**S-3790**  
**ORCHARD SUBDIVISION, PHASE 3, SECTION 1**  
**Major-Preliminary Plat**

**STAFF REPORT**  
**May 11, 2006**

PRELIMINARY\* PLAT  
ORCHARD SUBDIVISION, PHASE 3, SECTION

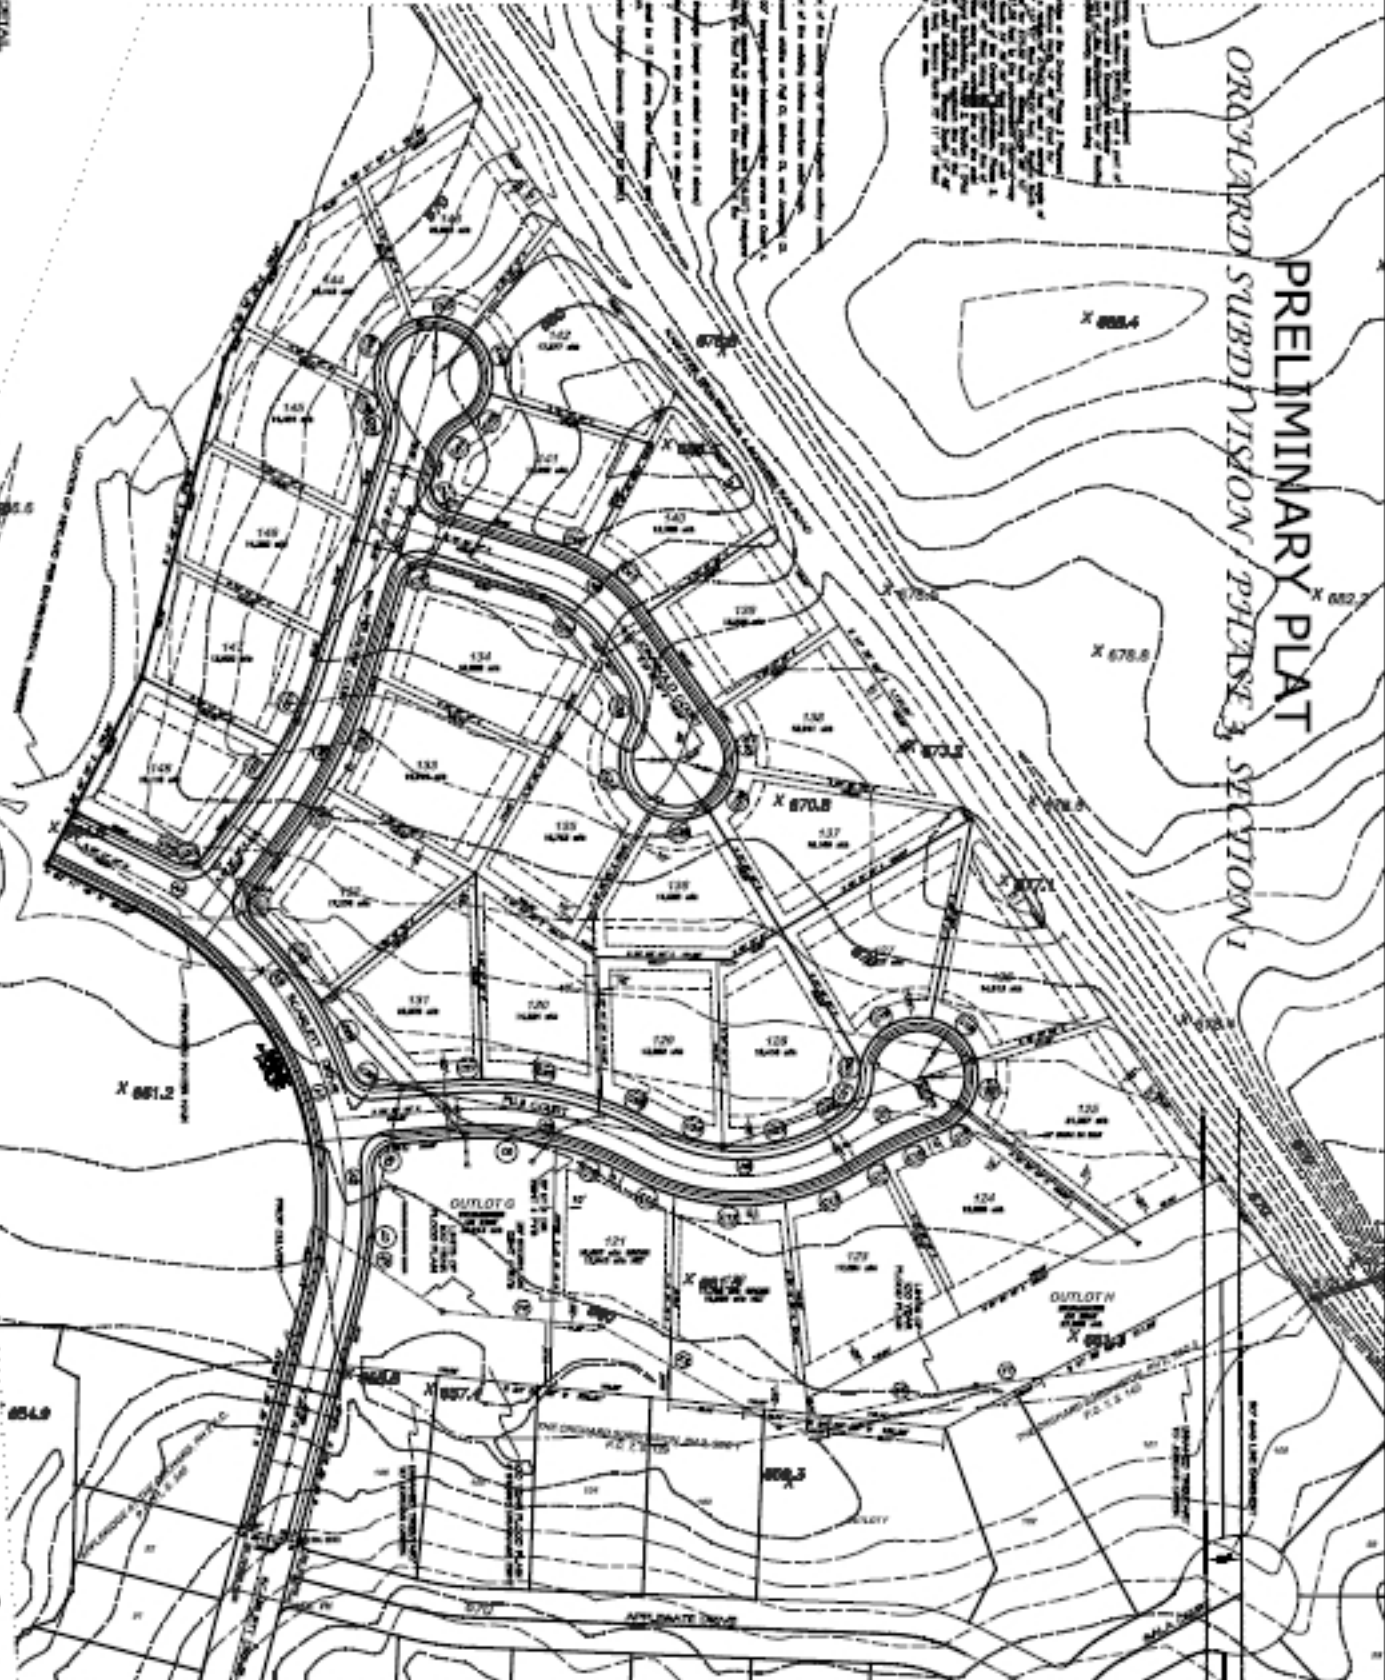
USO Section 5.3(2)(d) requires a 25-ft. buffer strip along the railroad right-of-way. This 25-ft. strip is in addition to the normal lot depth, but is not shown on the preliminary plat. On the final plat it must be noted as follows: "This strip is reserved for screening. The placement of structures hereon is prohibited."

This tributary bounds the site's south side and drains an area less than one square mile, and therefore falls outside the jurisdiction of the Indiana Department of Natural Resources (IDNR). The subdivider's engineer prepared a floodway analysis report to determine the 100-year flood elevations along the tributary and certify the Flood Plain boundary. Based on these elevations a new FP boundary has been shown on the preliminary plat with certification. The lots that border the tributary have been designed to meet the minimum lot area, excluding the area in the Flood Plain.

The developer has filed a setback variance request with the Area Board of Zoning Appeals that would reduce the front setbacks for Lots 121-124, from 25-ft. to 15-ft. The purpose of the request is to preserve as many of the trees on these lots as possible. The case is scheduled to be heard by the ABZA at its next meeting on May 24<sup>th</sup>. If the variance is granted, the reduced setbacks must be shown on the final plat with the variance case number and date approved. Otherwise, the standard 25-ft. front setbacks will be shown.

Conditional primary approval, contingent on the following:

1. A variance to eliminate two required 100-ft. tangents between reverse curves on Fuji Court.
2. A variance to reduce the required pavement width from 30-ft. to 28-ft. (measured from back of curb to back of curb) for Fuji Court, Melrose Court and Jonagold Court.

7. On the grading plan, the lowest floor elevation for any building pad within 100 ft. of the FP (Flood Plain) district shall meet the flood protection grade.

14. The purpose, ownership and maintenance of Outlots G and H shall be specified.
